# Road & Bridge Design Publications

## Monthly Update – October 2022

Revisions for the month of **October** are listed and displayed below and will be included in projects submitted for the **February** letting.

SHEET  
4 OF 10

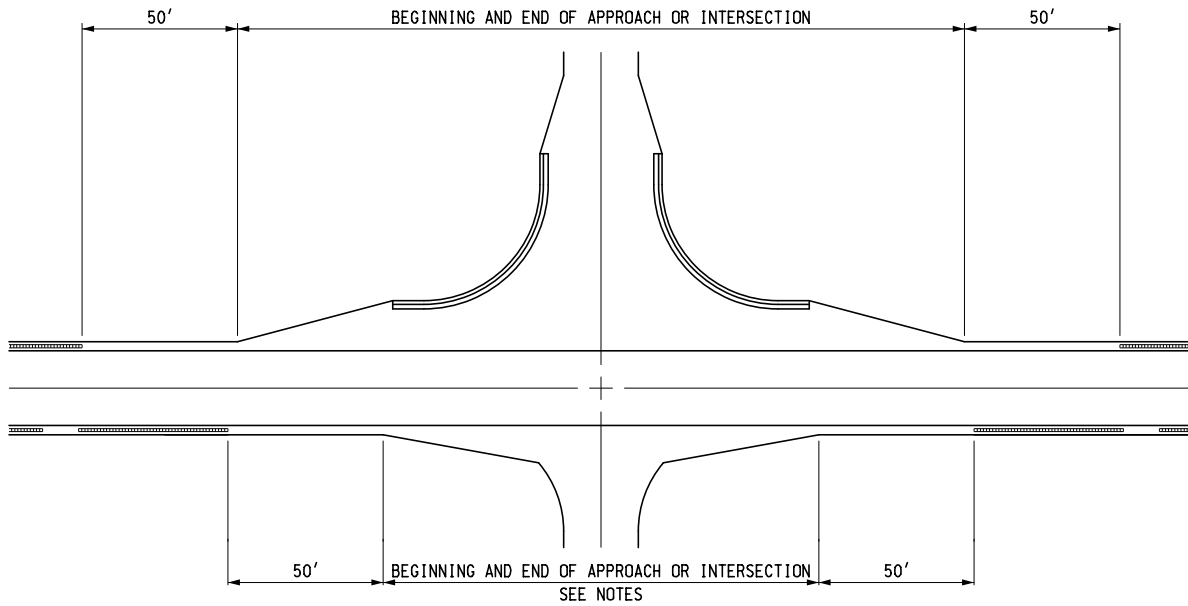
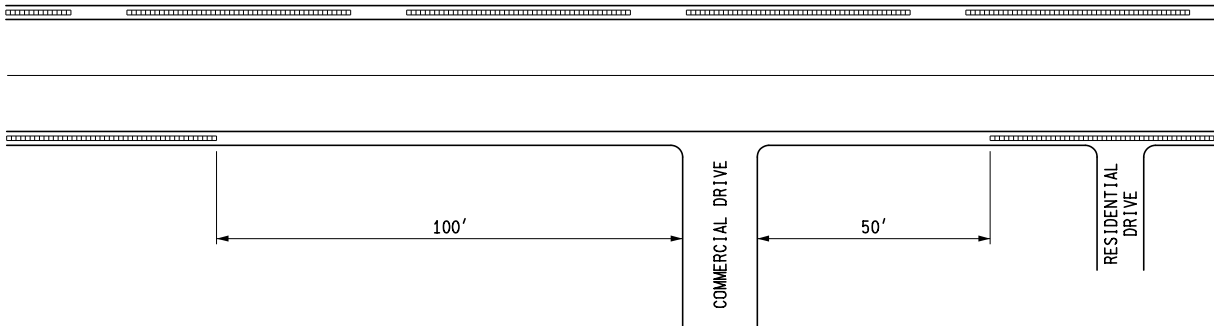
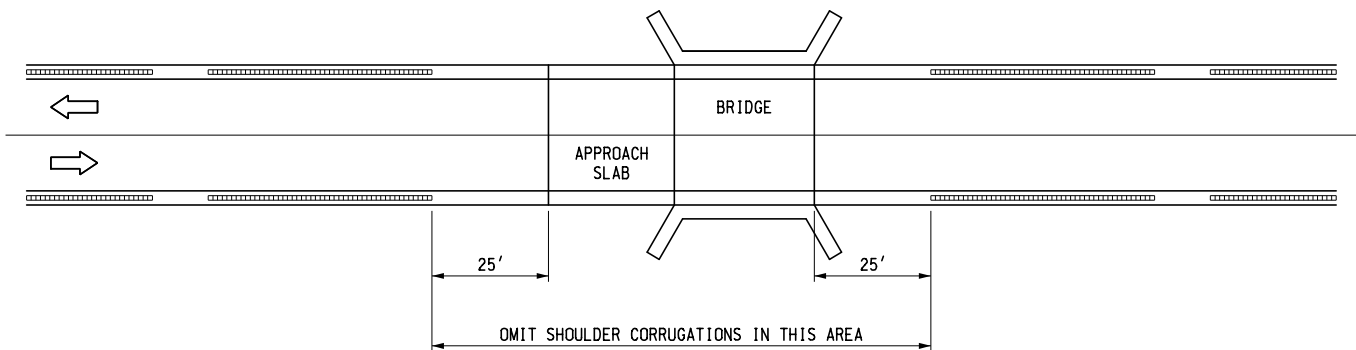
R-112-J: Shoulder and Center Line Corrugations: Revised the offset from a shoulder or centerline corrugation to the outside rail of RR tracks from 25' to 50'. Also revised the corrugation pattern on sheet 4 to match that of the other non-freeway shoulder corrugations.
